## **HAWK'S LANDING SUBDIVISION**

APPLICATION NUMBER 10 DATE September 7, 2006

REQUEST Subdivision

# DETAIL SITE PLAN

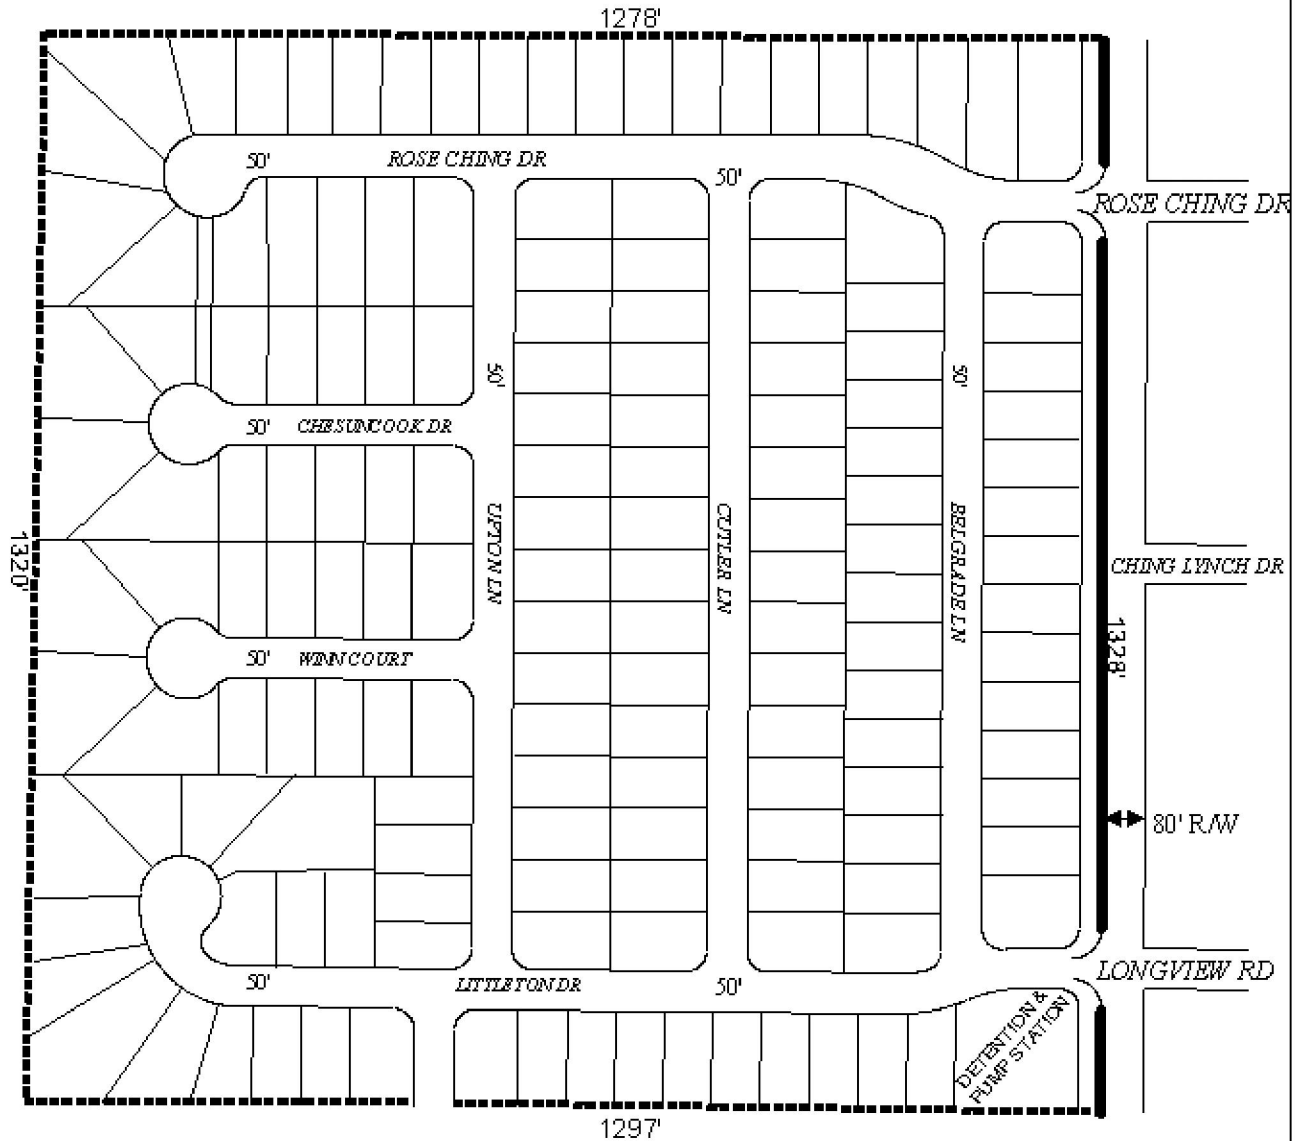
The site under consideration fronts Ching Dairy Road to the East, and a stub for Sky Terra Drive to the South. Ching Dairy Road is a proposed major street (Crawford-Kushla Connection), thus sufficient right-of-way should be dedicated to Mobile County to provide 50 feet, as measured from the centerline of Ching Dairy Road. Sky Terra Drive is a minor street with adequate right-of-way.

The dedication requirement for Ching Dairy Road may result in the lots with frontage onto Ching Dairy Road not meeting minimum lot size requirements. Therefore, all lots adjacent to Ching Dairy Road should be reviewed for size to ensure that each lot will meet the 7,200 square feet minimum lot size requirement of Section V.D.2. of the Subdivision Regulations.

Ching Dairy Road's status as a proposed major street means that access management is a concern. Curb-cuts onto Ching Dairy Road should be minimized, therefore a note should be placed on the plat stating that all lots are denied direct access to Ching Dairy Road.

The subdivision will connect to Sky Terra Drive to the South. The Subdivision Regulations recommended that intersections be offset a minimum of 125 feet, however the intersection of Littleton Drive with Sky Terra Drive is less than this distance from Littleton Drive's intersection with Upton Lane. The plat should be revised to provide the street offset recommended in Section V.B.11. of the Subdivision Regulations.

All proposed lots appear to currently meet the minimum size requirements of Section V.D.2. of the Subdivision Regulations. To ensure lot size conformance after the required dedication, it is recommended that the plat be revised to include the size of each lot in square feet as a label on each lot, or as a table on the plat.

The 25-foot minimum building setback line from all street frontages, required in Section V.D.9., is not shown for the subdivision, but would be required on the final plat, if approved.

There appear to be extra lot lines in the vicinity of lots 52-53 and 62-63. The plat should either be revised to remove these lines, or they should be labeled if they represent an easement or common area.

A detention area and pump station area is depicted on the Southeast corner of the site. The detention area, as well as all other common areas should be identified on the plat, and a note should be placed on the final plat, if approved, stating that maintenance of the detention and common areas is the responsibility of the subdivision's property owners.

There are two notes on the plat indicating that the site will be developed with 118 single-family homes units and 112 single-family townhome units, for a total of 230 units on 158 lots. If there is a discrepancy regarding the total number of units and the total number of lots, it should be resolved and appropriately noted on the final plat. If the total number of proposed units will be 230 units, an additional point of access to the site, perhaps as a street stub to the West, would be appropriate.

The legal description of the site is not shown on the preliminary plat. The plat should be revised so that the legal description is included on the final plat, if approved.

This site is located in Mobile County, thus a note should be placed on the Final Plat stating that any lots which are developed commercially and adjoin residentially developed property must provide a buffer, in compliance with Section V.A.7. of the Subdivision Regulations.

Based on the preceding, the subdivision is recommended for Tentative Approval, subject to the following conditions: 1) dedication of right-of-way sufficient to provide 50 feet, as measured from the centerline of Ching Dairy Road; 2) verification that each lot will meet the 7,200 square feet minimum lot size requirement of Section V.D.2. of the Subdivision Regulations, after the Ching Dairy Road right-of-way dedication, and labeling of all lots or provision of a table indicating the size in square feet of all lots; 3) placement of a note on the plat stating that all lots are denied direct access to Ching Dairy Road; 4) revision of the plat to provide the street offset between the Upton Lane and Sky Terra Drive intersections recommended in Section V.B.11. of the Subdivision Regulations; 5) identification of all common areas, and placement of a note on the final plat stating that maintenance of detention and common areas is the responsibility of the subdivision's property owners; 6) depiction of the 25-foot minimum building setback line; 7) clarification of the multiple lot lines in the vicinity of lots 52-53 and 62-63; 8) revision of notes 6 and 7 on the plat so that the total number of housing units matches the number of lots depicted on the plat (if there is an error), or if 230 total units are proposed, provision of an additional point of access to the site, perhaps as a street stub to the West; 9) placement of the legal description on the final plat, as required by the Subdivision Regulations; and 10) placement of a note on the final plat stating that any lots which are developed commercially and adjoin residentially developed property must provide a buffer, in compliance with Section V.A.7. of the Subdivision Regulations.
